HYUNDAI

Technical Service Bulletin

GROUP	NUMBER
ENGINE MECHANICAL	26-EM-005H
DATE	MODEL(S)
FEBRUARY 2026	SANTA FE (TMA)

SUBJECT: INTEGRATED THERMAL MANAGEMENT (ITM) REPLACEMENT & ECM/TCU SOFTWARE UPDATE – DTCS P218100, P2181F0, P2181F1

ITM Replacement

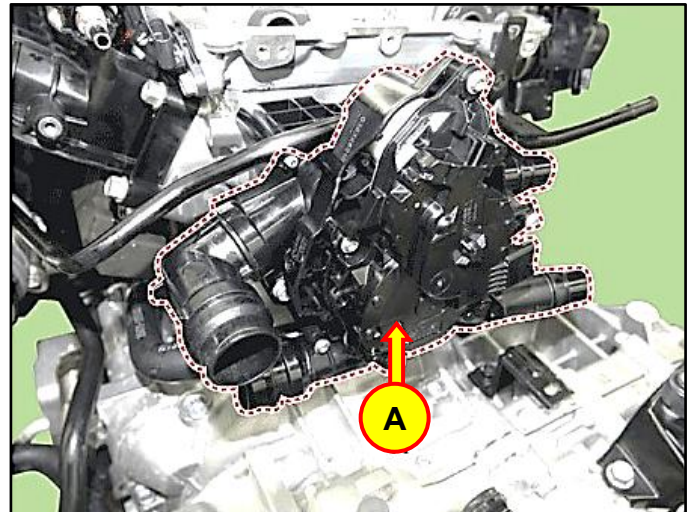
2. Replace the ITM (A) by referring to the shop manual.
 - **Engine Mechanical System > Cooling System > Integrated Thermal Management Module (ITM) > Repair procedures**

3. Reinstall parts in the reverse order of the removal process.

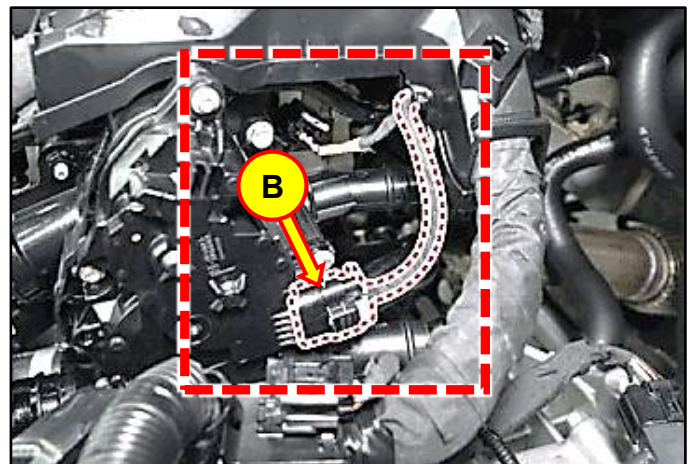
The ITM design inverts the connector's (B) orientation.
